<b>Project:</b> Proposed Double Storey Residence	<b>Client:</b> Sandy & Greg Marshall	<b>Address:</b> Lot 209 Heather Road Denmark	<b>Date:</b> 29/09/16 11/10/16	<b>Item:</b> ISSUE FOR COMMENT ISSUE FOR COMMENT	<b>CLIENT:</b> CLIENT CLIENT	<b>Drawn:</b> KH	<b>Date:</b> 11/10/2016	<b>Drawing Number:</b> A02 of 05	<b>Job No.:</b> C-1647-16
			<b>Rev. Date</b>	<b>Item</b>	<b>Issued To</b>	<b>Checked:</b> RF	<b>Scale:</b> AS SHOWN		<b>Stage / Revision:</b> DD-E

Project:  
Proposed Double Storey Residence

**SCHEDULE OF SUBMISSIONS: PROPOSED SINGLE HOUSE – NO. 43 (LOT 209) HEATHER ROAD, OCEAN BEACH (A5345; 2016/196)**

PROPOSED SITE PLAN  
Scale 1:100

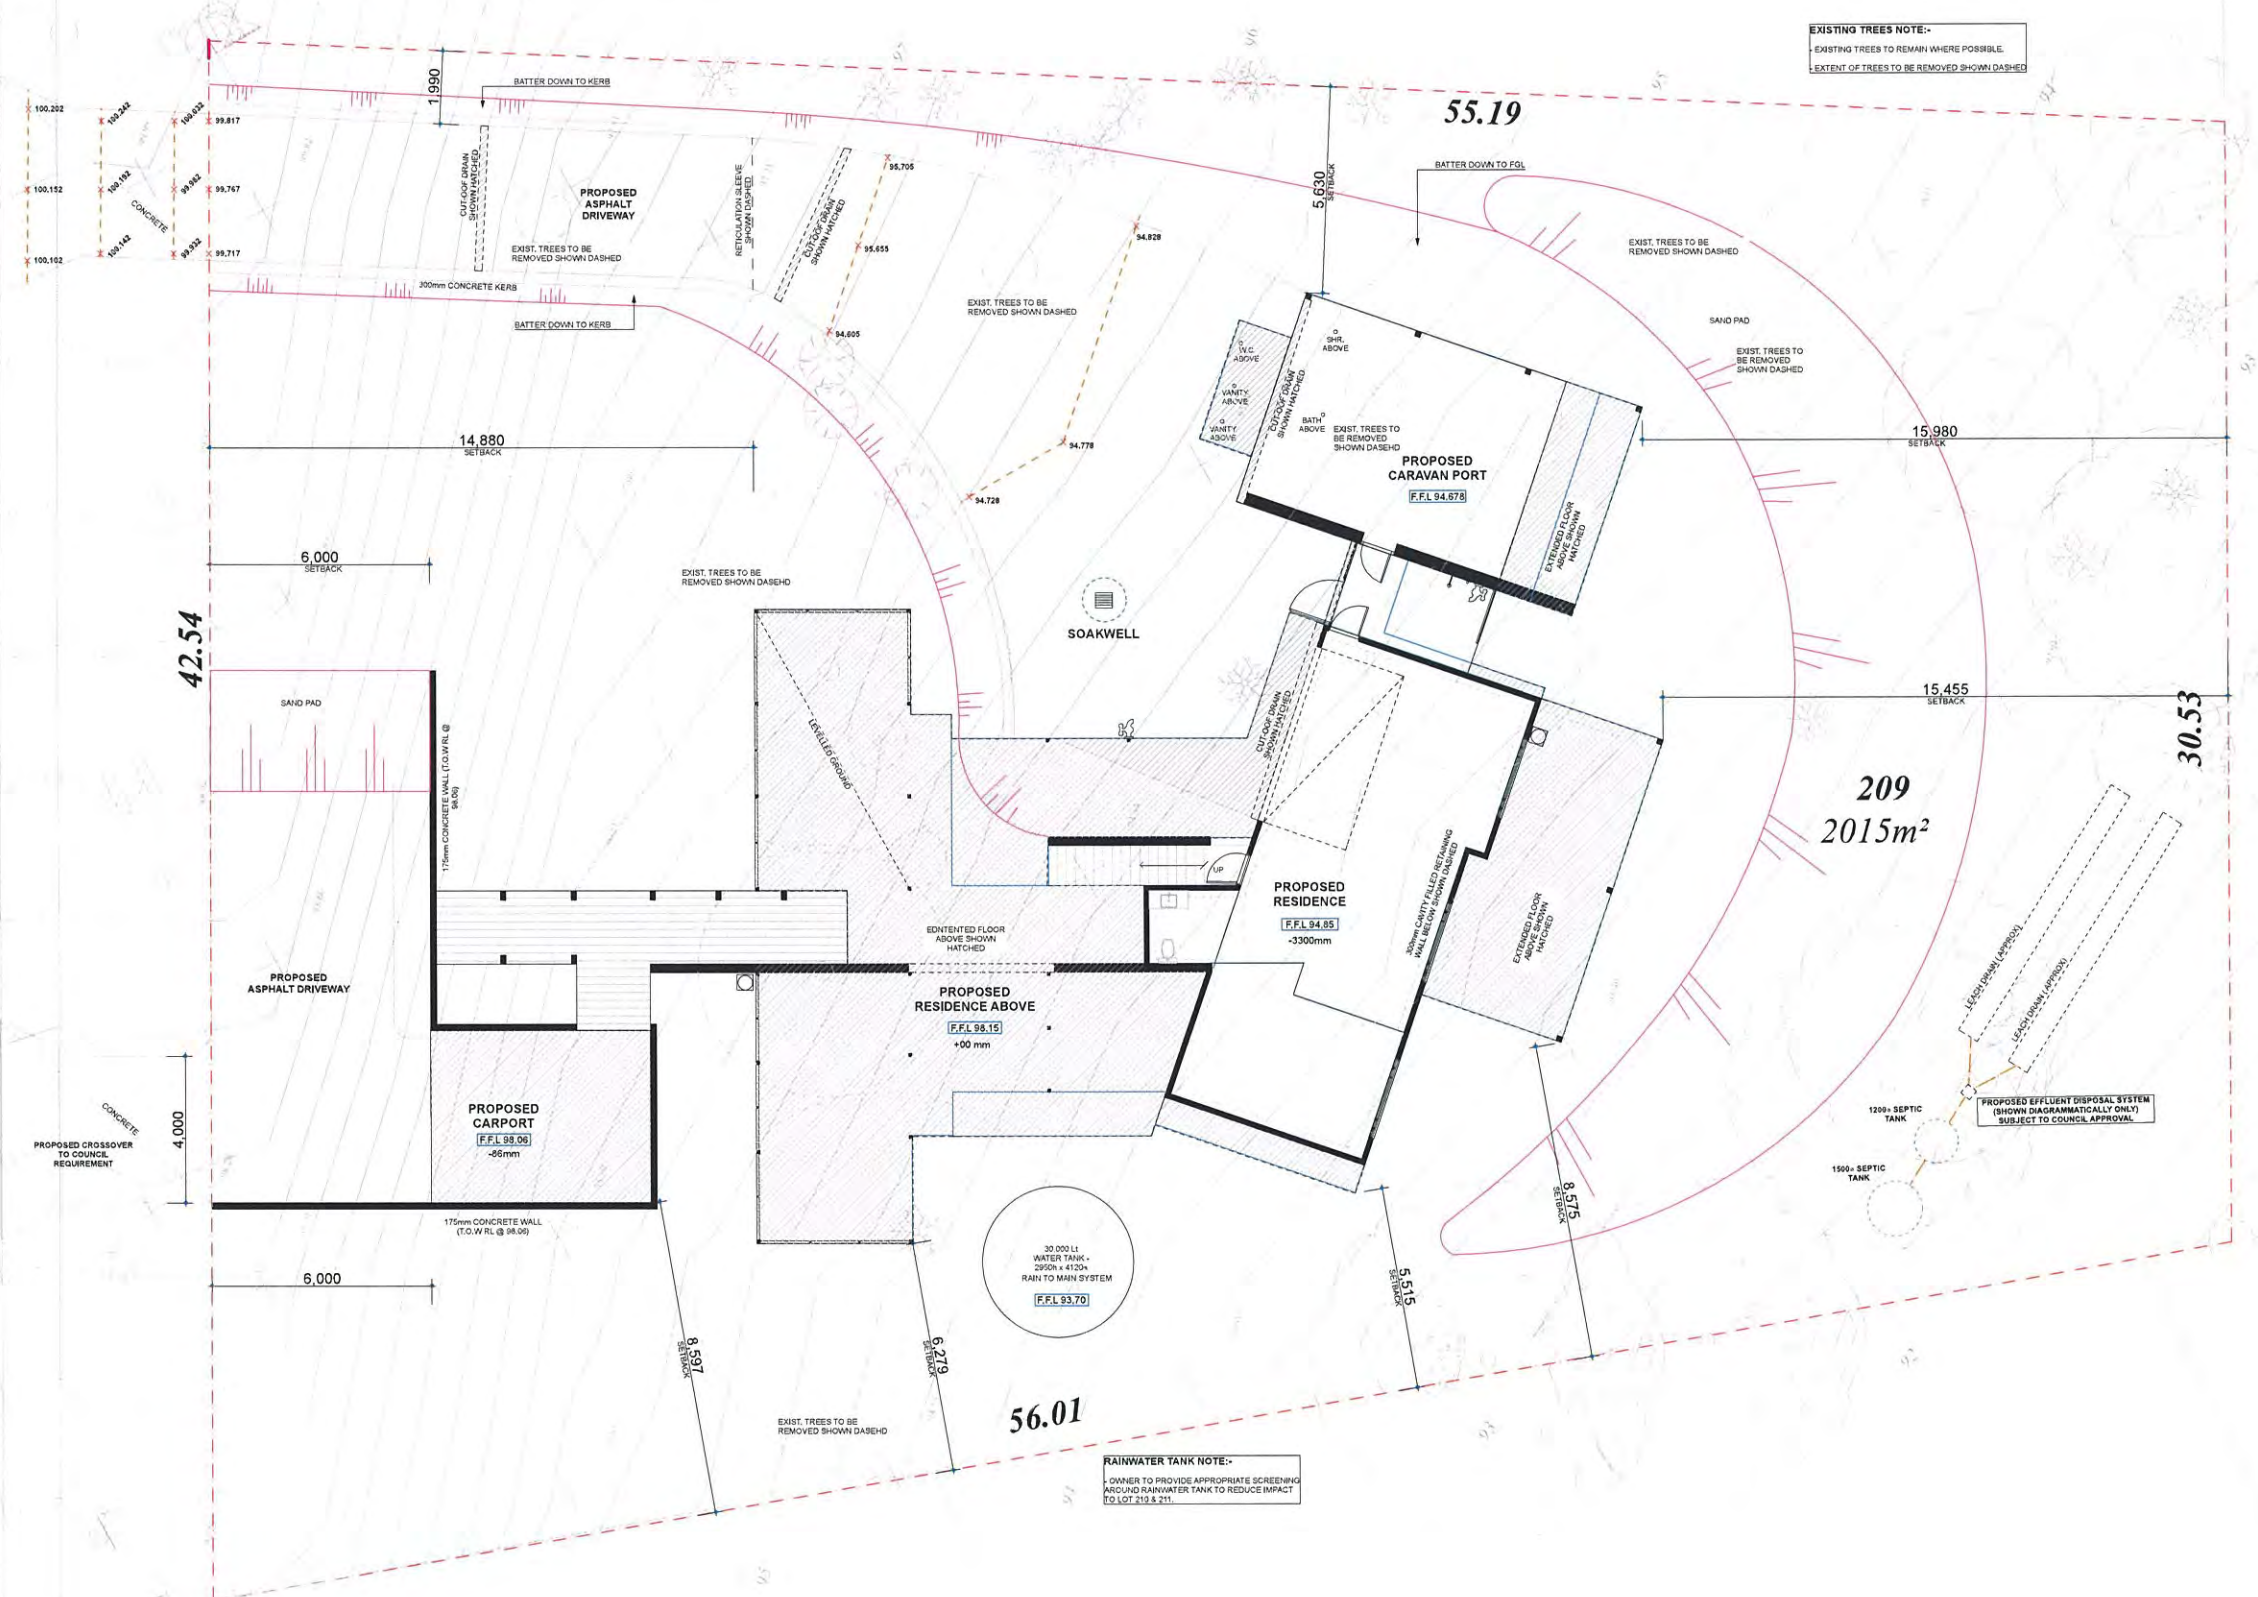
It is not clear from the information provided at what point on our lot one would have the view indicated on the diagram as "view from {address removed by Planning Services} ".

The revised plans again refer to some trees on their property, but this is not an appropriate screening device to counter the increased floor level height of the decking/alfresco areas which brings with it overlooking and increased noise levels. In any event, trees are not a permanent fixture.

<ul style="list-style-type: none"> <li>• The development complies with the overshadowing provisions of the R-Codes (Clause 5.4.2).</li> <li>• The applicant has marked on the revised plans dated 29 March 2017 which trees are proposed to be removed. The trees in question are indicated to remain. It is a standard condition on all development approvals where Bushfire Attack Level (BAL) Assessments are involved, that any trees not marked as proposed to be removed to achieve a nominated BAL Rating are required to remain. Should the applicant wish to remove these trees in the future, they may need to obtain a clearing permit from the Department of Environment Regulation if removal of the trees is not exempt.</li> </ul>
S3	<p>Details omitted as per Council Policy.</p> <p>Submitter is an adjoining landowner.</p>	<p>I refer to our previous exchange of emails and my telephone conversation with Mr Creedon. The current position is that we as owners of {address removed by Planning Services} have been given until 13 January 2017 to object to the proposed development on lot 209. I shall be down in Denmark between 7 and 21 January 2017, and may then supplement this objection, once I have had an opportunity to inspect the plans and look at the lots again. I shall however have restricted access to email and printing when down in Denmark.</p> <p>We were originally notified of the development by letter dated 9 December, received on 12 December 2016, from your Planning Services, signed by Ms Sampey (the initial letter). This enclosed some information and plans concerning a house to be constructed on lot 209, where an external wall or walls is/are to exceed the maximum height stipulated in the R-Codes, by 2.5 metres, ie go to 8.5 metres above natural ground level rather than 6 metres (the increased wall height). Although the initial letter says the height extension is "at the rear of the house", it is not clear where this extension is to take place, so hence my intention to probably supplement the current objection by 13 January once I have seen the plans at your offices, marked up to show the extension. It does appear to be the case that the extension area faces towards our lot. Further, the part of the house including the increased wall height appears to include living areas, large balconies and an outside bar area on the top storey created through the increased wall height.</p>	<ul style="list-style-type: none"> <li>• Planning Services accommodated the request by the submitters to view the plans even after the closing date and provided additional information via email and over the counter to show the extent of the development that did not comply with the Deemed-to-Comply criteria.</li> <li>• The R-Codes are not designed to be prescriptive as such; they incorporate Deemed-to-Comply criteria which provides for a relatively straightforward path to approval and a design principle approach for developments that do not meet the Deemed-to-Comply criteria such that a proposal can be considered on its merits. In this instance the applicant is seeking approval for a variation to the building height provisions of the R-Codes.</li> <li>• As per the R-Codes, visual privacy setbacks are referenced in the context of a 'cone of vision' setback. For active outdoor habitable spaces (i.e. decks,</li> </ul>

- While it is agreed that trees and other screening vegetation is not a permanent visual screen and can be problematic when poorly maintained or removed in the future, there is no requirement for screening devices to be provided for the proposed development as it complies with the R-Codes deemed-to-comply provisions for visual privacy. The existing vegetation between the subject lots will assist in ameliorating any perceived privacy/overlooking issues between the proposed development and any future dwelling on the adjoining lot. As outlined in the response to Submission S2, it should be noted that the applicant may not be permitted to remove these trees without receiving a clearing permit from the Department of Environment Regulation (if not exempt).

E01 ELEVATION 01 - SW Scale 1:100

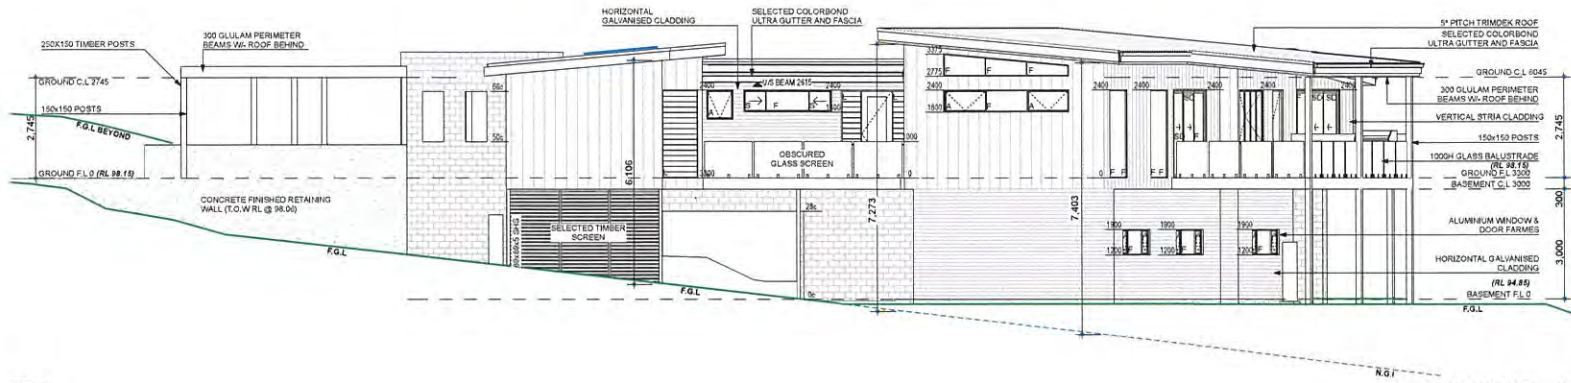
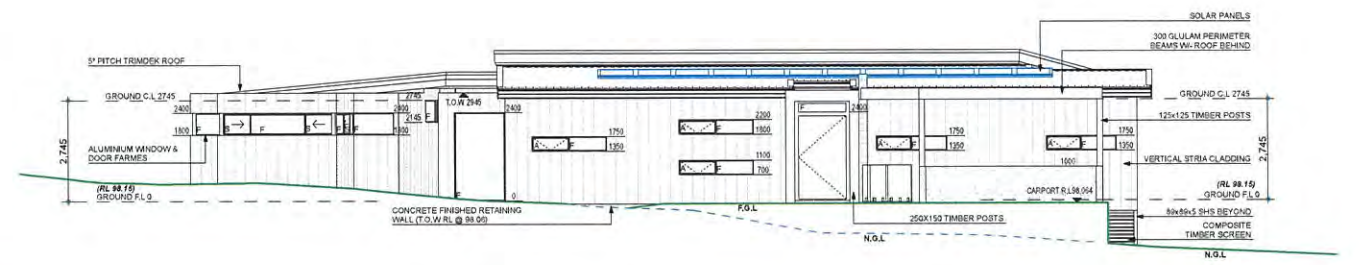
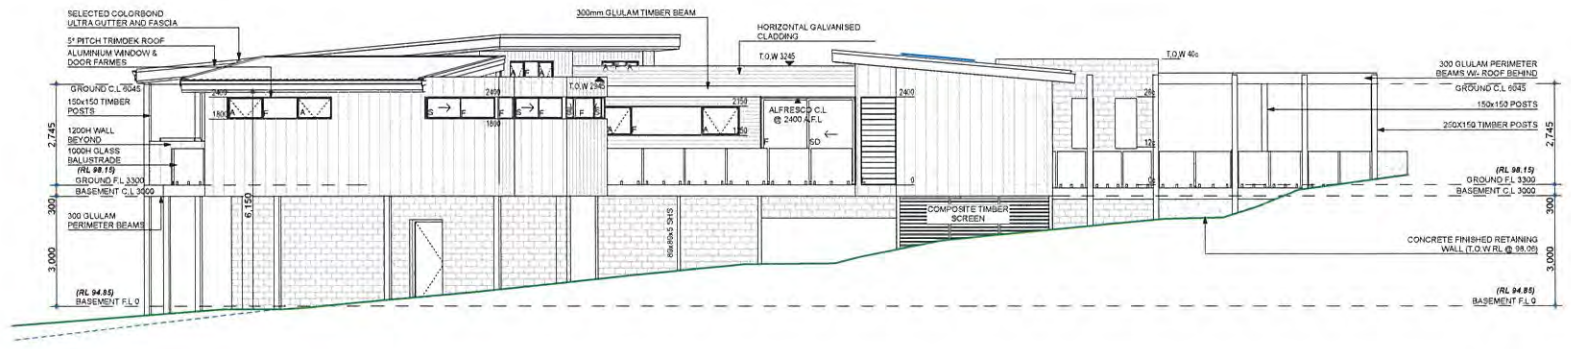
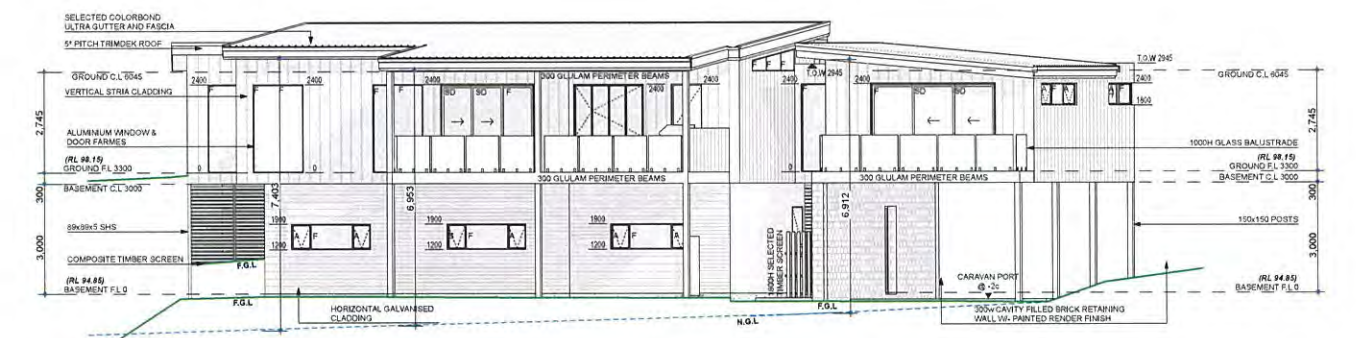
The revised plans presented to us continue to show external wall heights exceeding the R Code height of 6 meters by respectively going to wall heights of 6.9 m and 7.4 meters. These excessive wall heights are on the east/south eastern side of the proposed dwelling thus facing our lot {address removed by Planning Services}. The non-conforming wall heights cause unacceptable overlooking onto our lot. The height of 6.9 meters applies to the wall containing the decking in front of the main bedroom. The height of 7.4 meters applies both in the area of the extensive first floor alfresco area and in respect of two large windows on what appears to be the south-east external wall of the living room, to the south of the alfresco area.

It is disappointing to see that in our view no real effort was made to comply with the R Codes in the revised plans. The reduction in wall heights are really quite trivial and meaningless: from 8.176 m to 7.400 m (776 mm); and from

7.145 m to 6.9 (245 mm), when the R Code heights are being exceeded by 1.4 m and 0.9 m. It should be kept in mind that the limits on the maximum heights in the R Codes are not unusual or unduly restrictive but provide an appropriate and generally enforced design standard.

The revised plans refer to the “reduction of building bulk” by bringing the roof line on the south east side down. How this reduces “building bulk” is hard to understand, but it is in any event not a proper or recognized principle of planning or design. This argument may suggest that the overall wall height will “look” lower because of the roof overhang. But, for one, this does not address in any way the elevated decking/first floor alfresco area floor height from the ground.

<ul style="list-style-type: none"><li>• The walls in question which exceed 6 metres in height do not directly adjoin the submitter's property and are located east of where the submitter's northern boundary adjoins the subject lot. The amended plans provide for a maximum wall height of 7.4 metres above natural ground level at the highest point (achieved by reducing the FFL of the building and a reduction in the upper storey wall heights). The 1.5 metre concrete retaining wall at the rear of the dwelling has also been removed and replaced with natural earth banking, thus reducing the bulk of the building substantially and the appearance of its height in relation to ground level.</li><li>• The portions of the dwelling which exceed 6 metres in wall height do not directly adjoin the submitter's property. While it is appreciated that views may currently be enjoyed by the submitter across the vacant lot, it is likely that any dwelling (including a single storey dwelling) constructed on the property would interfere with existing views to the north. Notwithstanding this, it is clear that the intention of the Heather Road subdivision was to take advantage of views south-east towards Wilson Inlet and Ocean Beach. This is demonstrated by the fact that properties on the streets south-east of the subject sites have restrictive covenants registered against their Certificate of Title limiting building height to 5 metres, so ensure dwellings on Heather Road maintain inlet/ocean views. The proposed dwelling will not impact the existing inlet/ocean views enjoyed by the submitter. Furthermore, given the orientation of the submitter's</li></ul>
